## JOINT REGIONAL PLANNING PANEL (Sydney East Region)

<b>Panel Reference</b>	2016SYE068
<b>DA Number</b>	DA-2014/445/C
<b>LGA</b>	Willoughby City Council
<b>Proposed Development</b>	<i>S96 - Inclusion of 17 Albert site to extend the childcare centre, add 13 apartments and increase onsite car parking provision and associated works</i>
<b>Street Address</b>	36-38 Hercules Street, 17 Albert Avenue & 256-260 Victoria Avenue, CHATSWOOD NSW 2067
<b>Applicant/Owner</b>	Chatswood Place Pty Ltd / Oscar Pty Ltd & Hercules Thirty Six Pty Limited
<b>Number of Submissions</b>	1
<b>Regional Development Criteria (Schedule 4A of the Act)</b>	Revised Capital Investment Value (CIV) is \$83,061,087.00
<b>List of all relevant s79C(1)(a) matters</b>	WLEP 2012; SEPP State and Regional Development 2011 (SRD SEPP); Deemed SEPP Sydney Regional Environmental Plan (Sydney Harbour Catchment) 2005; SEPP 55; SEPP Building Sustainability Index: BASIX 2004 (The BASIX SEPP); SEPP 65; Residential Flat Design Code; Draft WLEP; Draft Apartment Design Guide (Draft ADG); WDCP; S94A Plan.

**JRPP NO:** 2016SYE068  
**COUNCIL:** WILLOUGHBY CITY COUNCIL  
**ADDRESS:** 36-38 Hercules Street, 17 Albert Avenue &  
256-260 V

Figure 2 – Proposed continuation of Oscar Street South elevation on the corner lot at 17 Albert Avenue showing Height non-compliances

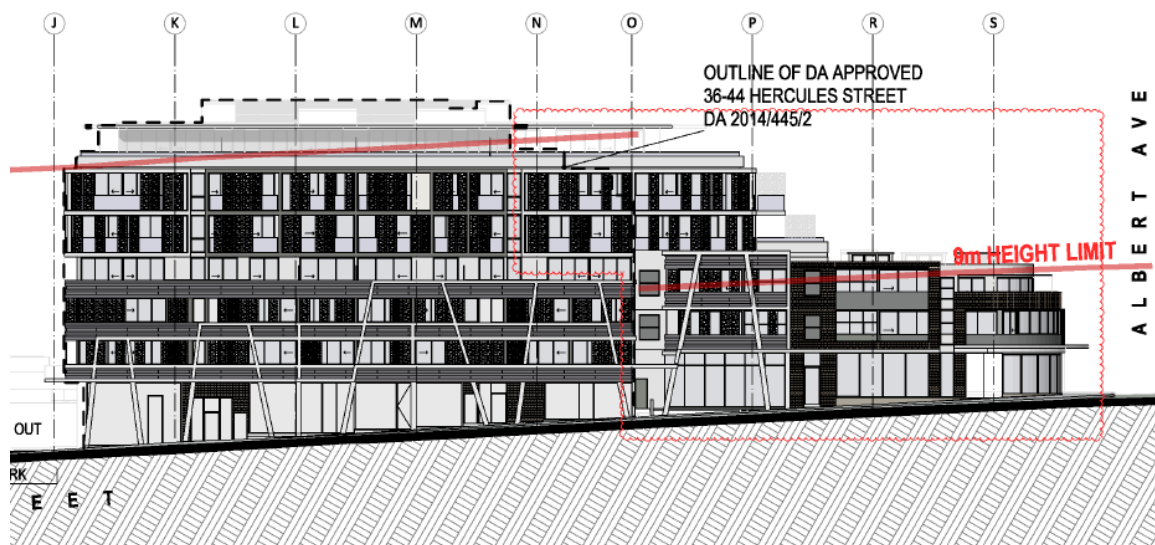
As a result of the including the previously isolated site at No 17 Albert Avenue and extension of the approved mixed-use development over this area, the proposal has a limited area with variations up to 12.11m above the 9m height limit. This is to allow for a reasonable transition of building height from the approved over 20m tall buildings along Oscar Street to the 9m building fronting Albert Ave.

The proposal involving the extension of the approved built forms in a cohesive manner and is consistent with the streetscape presentation of the approved development. The transition in scale from the low-density residential developments along Albert Avenue to the higher density business, retail and residential development to the north along Victoria Avenue will be maintained by the modified development. The modified development proposes a 3 storey built form along Albert Avenue in a similar manner as the approved development.

The modified development will not cause unreasonable external impacts such as view loss, visual intrusion or privacy issues or unacceptable overshadowing.

The modified development's non-compliance with the building height control standard in Clause 4.3(2) of WLEP 2012 is acceptable for the reasons outlined below:
